Item ID: D206-667-103

Item Name: Crosstube Fwd

DRAWING NO. D206-667-143	TITLE CROSSTUBE ASS'Y (206L HIGH FWD)	REV. C	DART AEROSPACE LTD ENGINEERING ORDER		D.E.O. NO. D206-667-143-C-1	SHEET NO. SHEET 1 OF 1	SCALE NTS
DRAWN 97	CHECKED ASS	MFG. APPR. 12	APPROVED WD	DE APPR. H			
DATE 11.07.15	DATE 11.07.20	DATE 11.07.21	DATE 11/07/21	DATE 11.07.21

DETAIL P
BONDING STRAP INSTALLATION 2 PL

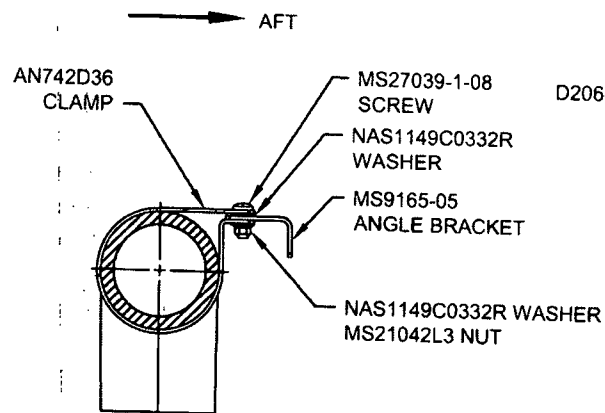
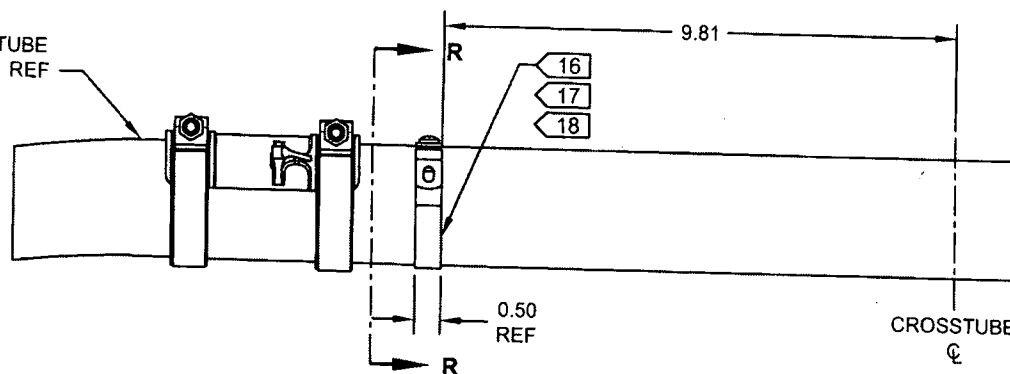
ADD ELECTRICAL GROUNDING STRAP

- 16) MASK AREA UNDER CLAMP PRIOR TO PAINTING
- 17) SEAL EDGES WHERE AN742D36 CLAMP MEETS WITH THE CROSSTUBE USING SIKAFLEX-241/291 OR MIL-S-8802 CLASS B2 OR PROSEAL 890 SEALANT
- 18) PERFORM RESISTANCE CHECK TO ENSURE MAX RESISTANCE IS 10 MILLIOHMS
